South Tyneside College

S278 Road Safety Audit Designers Response

Reference	S278 Road Safety Audit Designers Response 24185 - TA
Client Name	Castle
Date	June 2025
Version	P01

Figure 1 – Argos Service Yard Swept Path Analysis

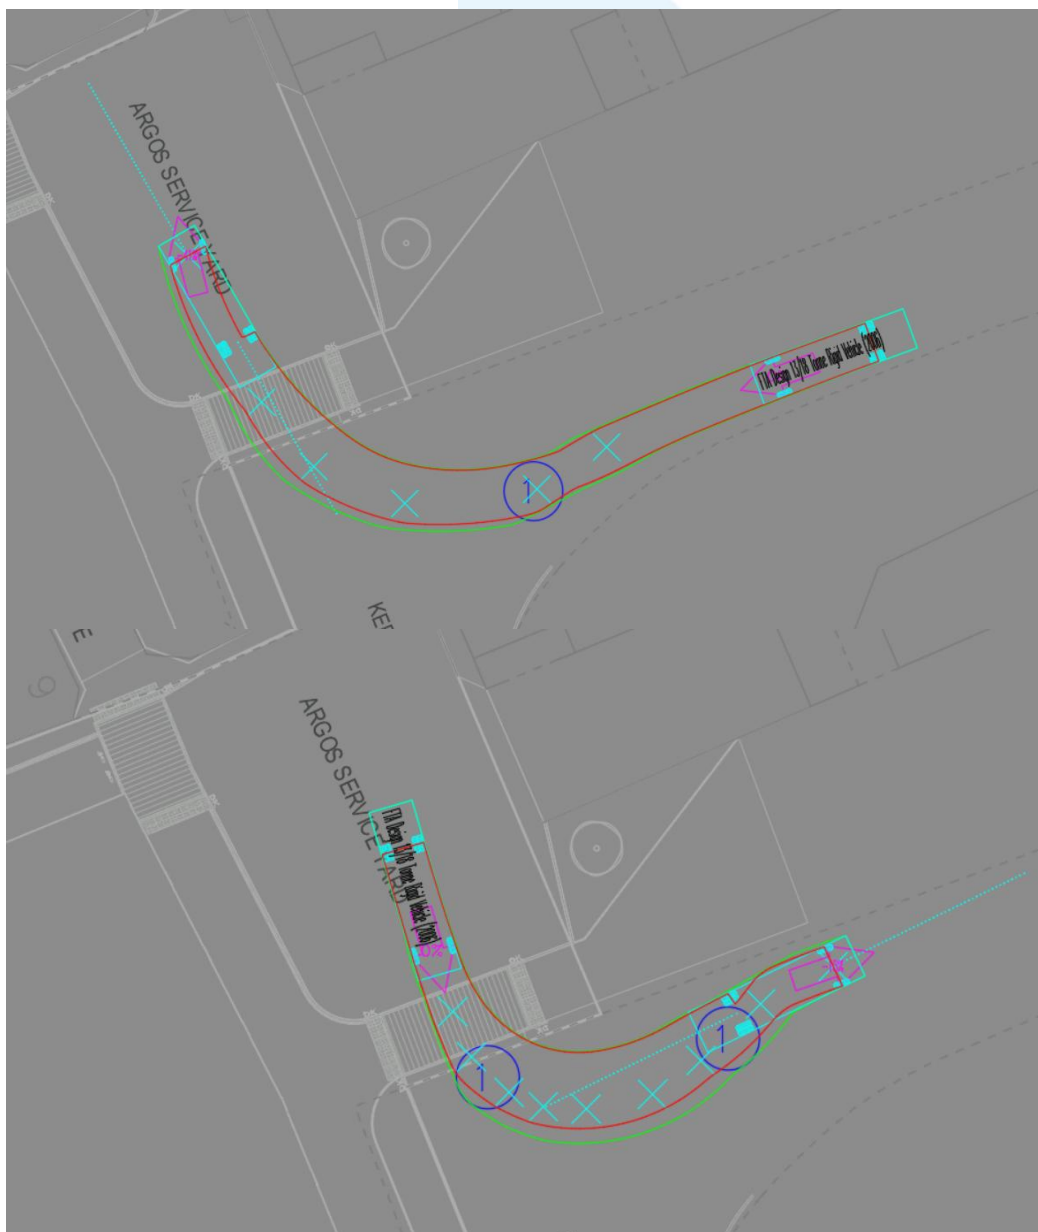
Problems 2.1.1, 2.1.2

Figure 1 shows a 18 tonne vehicles movements into and from the service yard. The paths shows that a radii on the junction is not required in this instance.

Figure 2 – Zebra Crossing

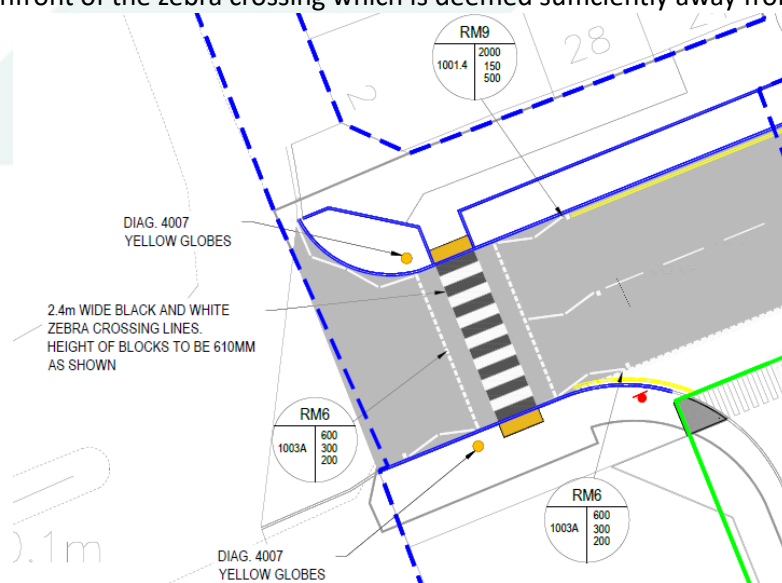
Problems 2.4.3, 2.4.4, 2.4.5

Following the Stage 1 & 2 recommendations, LTN1/95 Appendix C Option Assessment, and Traffic Signs Regulations and General Directions Chapter 6 14. Option assessment have been reviewed and a Zebra Crossing has been implemented on the junction within Chapter Row. The blister paving is in accordance with the Department of Transport, 'Guidance on the Use of Tactile Paving Surfaces' with 800mm present in front of the zebra crossing which is deemed sufficiently away from the junction.
